ACCESSION# NBR: 81120405721 DOC. DATE: 81/11/18 NOTARIZED: NO DOCKET#
 FACIL: 50-397 WPPSS Nuclear Project, Unit 2, Washington Public Power 05000397
 AUTH. NAME: AUTHORITY AFFILIATION
 BOUCHEY, G. DI. Washington Public Power Supply System
 RECIP. NAME: RECIPIENT AFFILIATION
 SCHWENCER, AL. Licensing Branch 2

Subject: SUPPLY SYSTEM NUCLEAR PROJECT NO. 2
GEOSCIENCES BRANCH QUESTIONS

Reference: Letter, R.L. Tedesco to R.L. Ferguson,
"WNP-2 FSAR - Request For Additional
Information", dated July 22, 1981

361.15

LOCATION MAP FOR ROCKWELL HANFORD
OPERATIONS SEISMIC REFLECTION LINES
1 AND 2

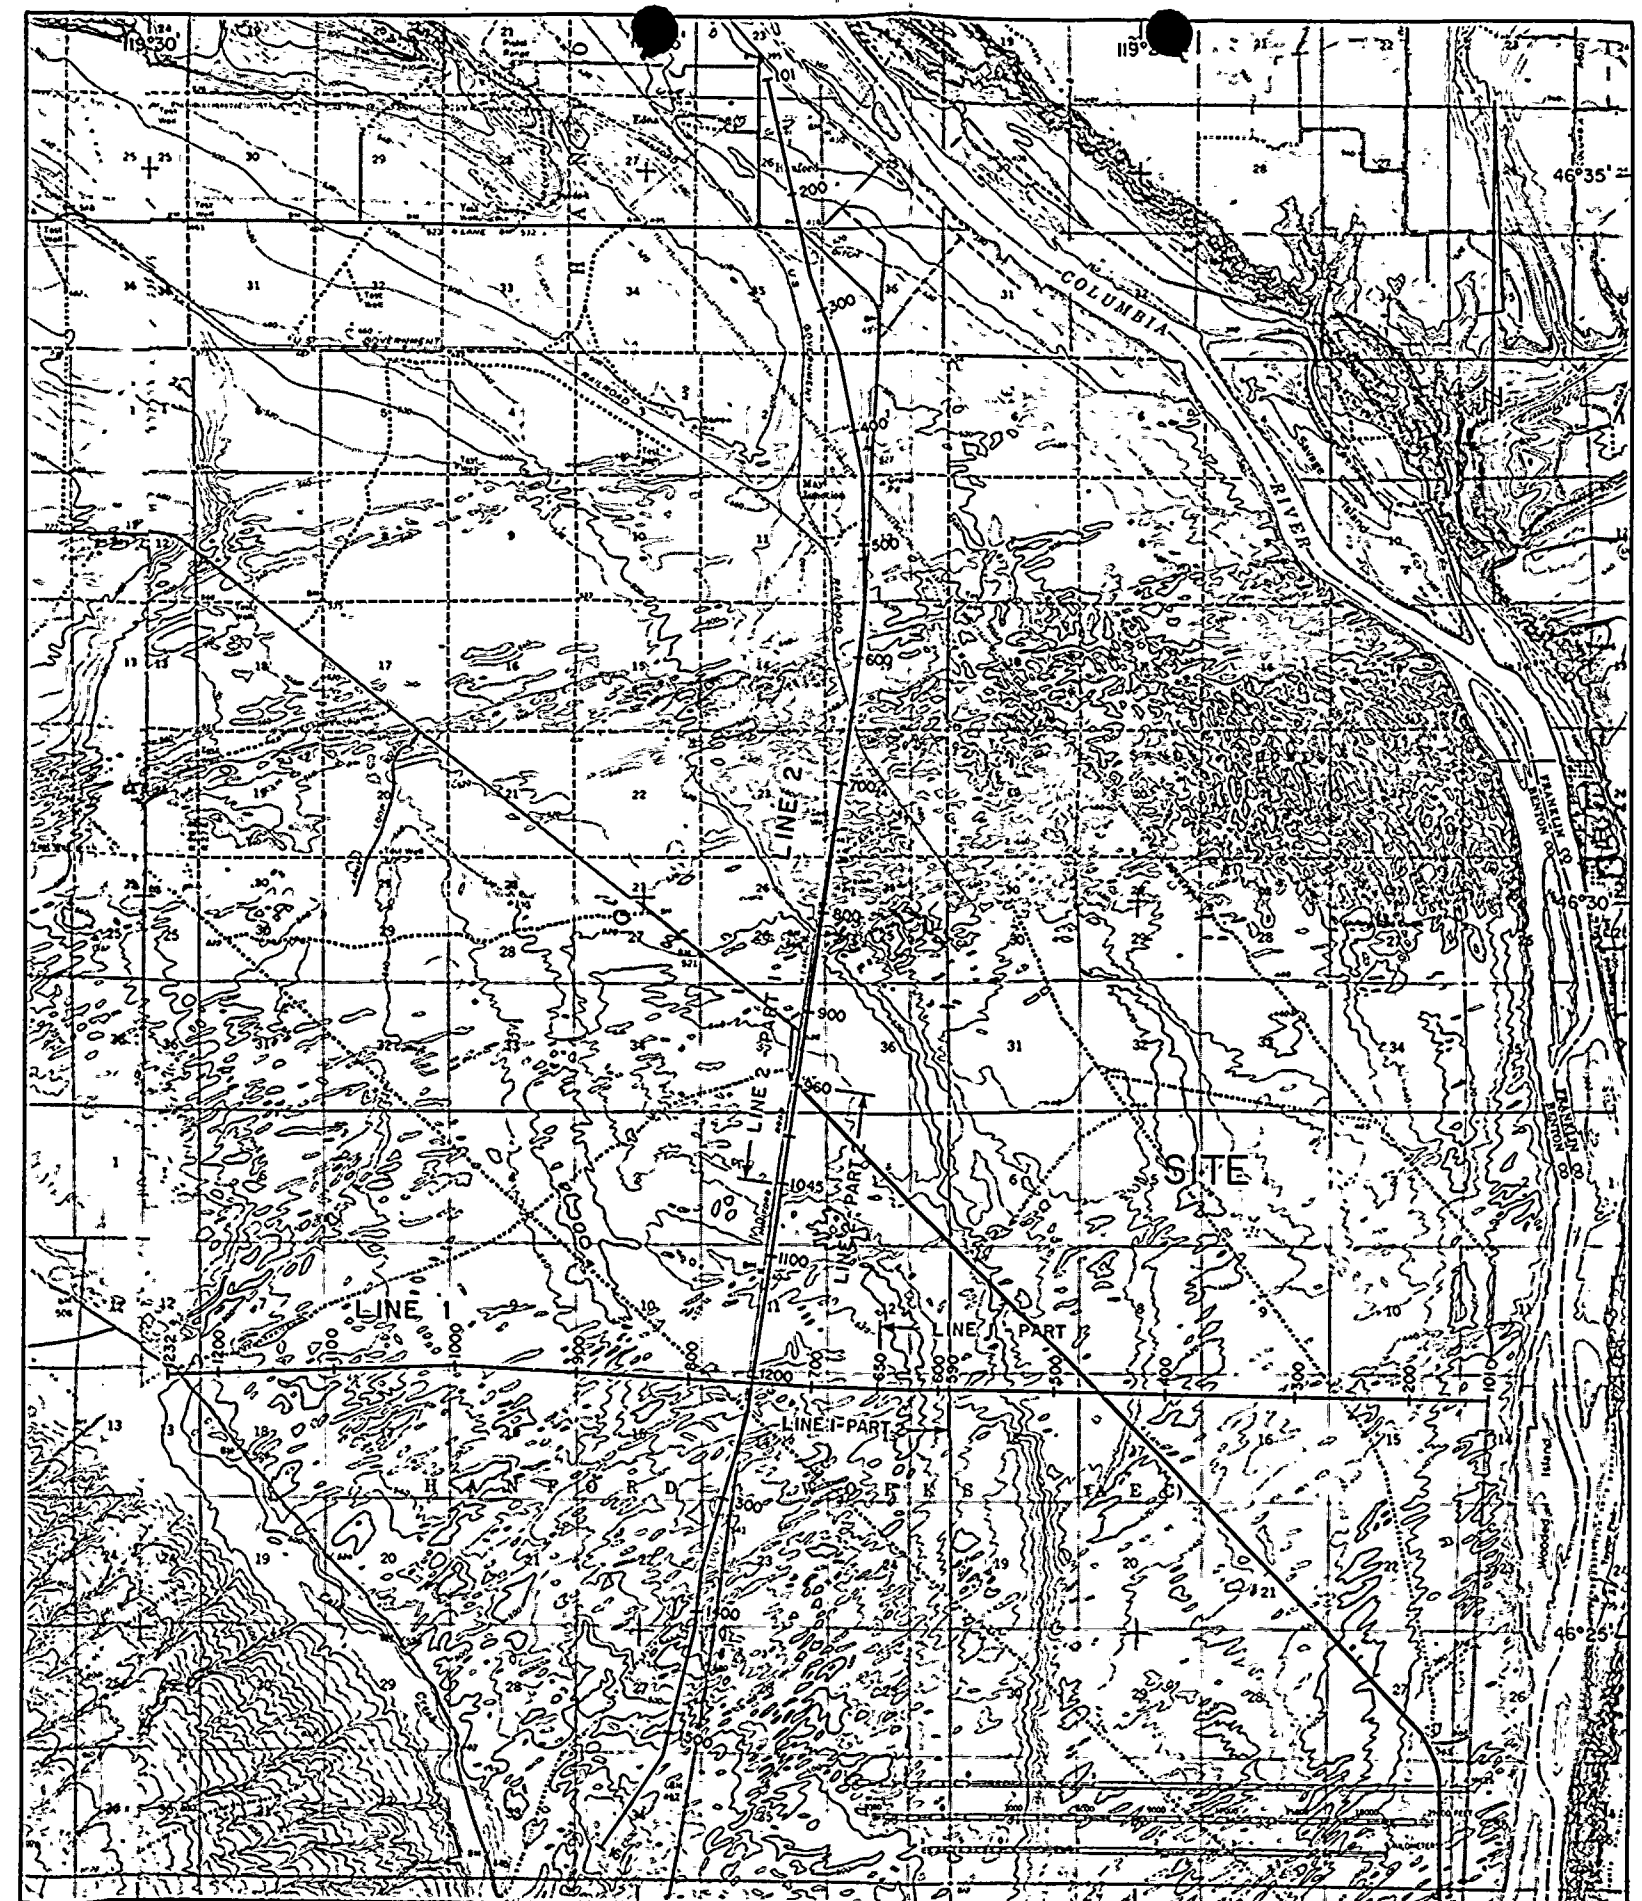
The seismic reflection data from WNP-2 are potentially significant for gaining an understanding of the geological structure near WNP-2. Present, interpret and discuss the lines relevant to the site and especially lines 1 and 2 shown in Figure D-1 in the Rockwell Hanford Report (RHO-BWI-ST-4).

Seismic reflection data (Figure 361.15-1) on the Hanford Reservation were acquired in 1979 and 1980 in conjunction with the proposed siting of a nuclear waste repository (Myers and Price, 1979) and are presented on Figures 361.15-2, -3, -4 and -5. Data were acquired by Seismograph service Corporation under contract to Rockwell Hanford Company for the Department of Energy using a standard vibroseis technique. Apparently, because of the specific interest in the basalts at a depth of approximately 1 to 2 kilometers, sweep length was limited to 10 seconds at 30 to 120 hertz input. The net result was data with penetration limited to about 1 second (2 to 3 kilometers) within the basalt sequence. The data that were recorded are of marginal quality. No continuous reflectors are evident, although a zone of discontinuous reflectors can be seen locally at the approximate Ringold sedimentary and basalt interface zone. No reliable structural interpretation appears to be possible because this interface zone is shallow (occurring at an average depth of less than 150 meters below the surface through the Hanford Reservation) and is known to have significant lateral velocity variations (including velocity inversions). In addition, these reflectors were oftentimes obliterated during processing by normal move out, stacking corrections and filtering. For example, where line 2 crosses the Gable Mountain structure over its south-east extension, only the gross shape of the anticline could be discerned. However, except for the Gable Mountain structure, no other features indicative of significant geologic structure could be seen on any of the seismic reflection lines. On lines 1 and 2, around the WNP-2 and WNP-1/4 sites, there appears to be no correlation of the reflector data with any geologic features that have been identified from the borehole or geophysical data.

A detailed evaluation of one portion of line 2, west of the FFTF site, was made (Figure 361.15-1). A review of the processed records and correlation with existing boring and seismic refraction profile information disclosed that the seismic reflection data in their present form are not suitable for a reliable interpretation. In some instances, the reflector appears to be the surface of basalt and correlates with refraction data and/or boring logs. In other instances, the reflector appears to correlate with materials at shallower depths, such as a cemented horizon in the Ringold Formation whose velocity determined from refraction is about 10,000 ft/sec, as contrasted with a velocity value of 16,000 ft/sec for the basalt.
